Access Compliance Report

Public Rights-of-Way

(Curb Ramps)

Intersection ID: 2458	Main Street: HIGHLAND_CREEK_PY	Cross Street: MCCHESENEY_DR	Location: W
ADA ID: 81A2530E682C	Ramp Type: Perp	Initial Pass/Fail: Fail	Overall Compliance: No
Codes/Mitigation Info/Possible Solution		Field Measurements/Component Compliance	
Severity Score: 21.25

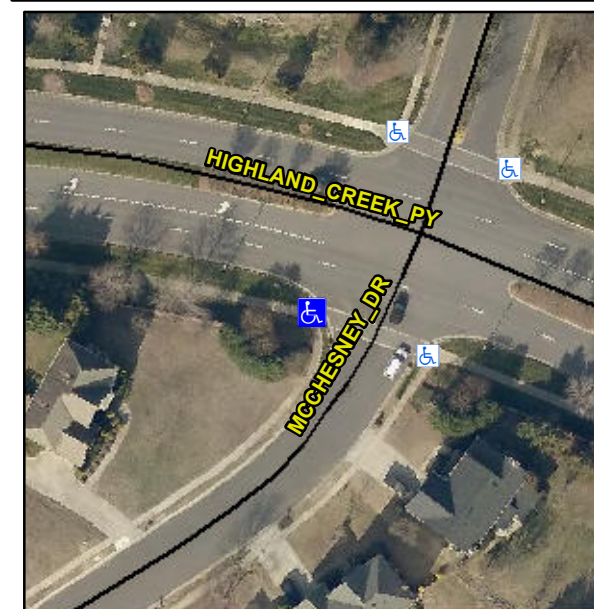
R304.5.1, R304.2.2

Compliance	Description	Data	Compliance	Description	Data
N/A	Ramp Length (in)	84.0	No	Ramp Slope (%)	8.4
No	Ramp Width (in)	38.0	Yes	Ramp XSlope (%)	1.1
N/A	Flare Type LT	N/A	N/A	Flare Type RT	N/A
N/A	Flare Slope LT (%)	N/A	N/A	Flare Slope RT (%)	N/A
N/A	Flare Traversable LT?	N/A	N/A	Flare Traversable RT?	N/A
N/A	Landing Length (in)	N/A	N/A	DWS Provided?	N/A
N/A	Landing Width (in)	N/A	N/A	DWS Contrast?	N/A
N/A	Landing Slope (%)	N/A	N/A	DWS Length (in)	N/A
N/A	Landing X Slope (%)	N/A	N/A	DWS Full Width?	N/A
N/A	Landing Curb? (Y/N)	N/A	N/A	DWS Offset (in)	N/A
N/A	Shared Landing?	N/A			
N/A	Gutter Ponding?	N/A	N/A	Gutter Slope (%)	N/A
N/A	Gutter Lip Ht (in)	N/A	N/A	Gutter X Slope (%)	N/A
N/A	Painted X Walk1?	Yes	N/A	Painted X Walk2?	N/A
	X Walk 1 Direction	To SE		X Walk 2 Direction	N/A
N/A	X Walk 1 Width (in)	98.0	N/A	X Walk 2 Width (in)	N/A
	X Walk 1 Slope (%)	2.0		X Walk 2 Slope (%)	N/A
	X Walk 1 X Slope (%)	0.7		X Walk 2 X Slope (%)	N/A

N/A	Ramp inside XWalk1?	No	N/A	Ramp inside XWalk2?	N/A
	Road Slope (%)	N/A	N/A	Clear Space?	N/A
	Road X Slope (%)	N/A	N/A	Clear Space to XWalk (in)	N/A
N/A	Any Obstructions?	N/A	N/A	Storm Grate/Utility Hazard?	N/A
	Obstruction Type			Storm Grate/Utility Type	
		N/A			N/A
		Yes		Surface Condition? (G/P)	Good

**Remove & Replace Entire Ramp.
Restripe Crosswalk.**
